Service Bulletin 157

Subject: Glasair IIS 200hp RG Engine Mounts; Part No.: 222-0269-103

Applicability: Engine mounts delivered between June, 2001 and March 2005

Figure 1: Measurements on acceptable mounts.

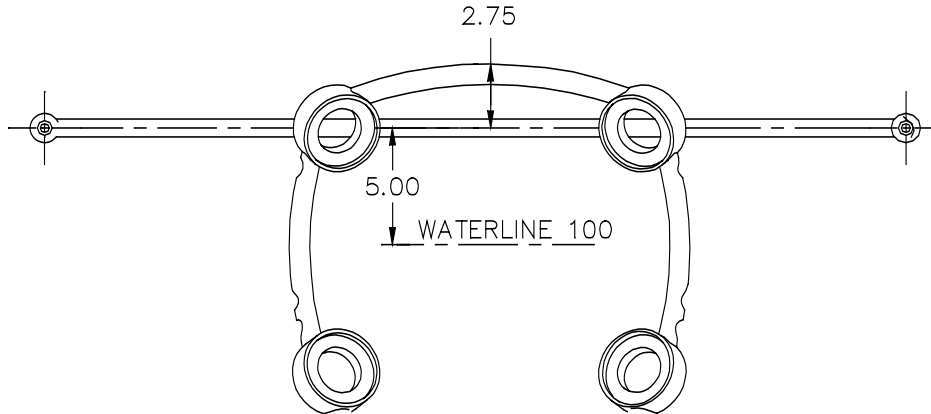
Glasair Aviation has recently discovered an inadvertent change was made to the engine mounts by our outside vendor. This change may affect the fit of the upper cowl with respect to the height of the upper tube between the upper two dynafocal mounts. Thus far, there has been only one known case of interference.

Required Action: If you have already installed the engine mount and you have determined there exists satisfactory clearance between the described center tube and the upper cowl as shown in Figure 1, no further action is required.

If you have not completed installing the engine mount and the cowling on the aircraft, it is required you measure the height of the upper tube relative to the upper two firewall mounting points before continuing with the firewall forward installation.

The mount can be measured on the ground or hung on the firewall if that is an option. The maximum distance between the top surface of the center tube to a horizontal centerline defined by the two upper engine mount attach points on the firewall **should be approximately 2.75** inches as shown in Figure 1. This would place the top of the tube at approximately **waterline 107.75**.

The mounts that were modified would have a noticeable error of approximately **1-1.5" higher than this dimension**. This would place the measured dimension at approximately 3.75 – 4", which would equate to waterline 108.75 or higher.

What to do if your mount exceeds the acceptable range.

If your measurement exceeds this acceptable dimension as discussed above, you are required to return the engine mount directly to the engine mount vendor. If you respond to this service bulletin by **May 31, 2005**, your mount will be repaired (or replaced) and returned at no charge to you.
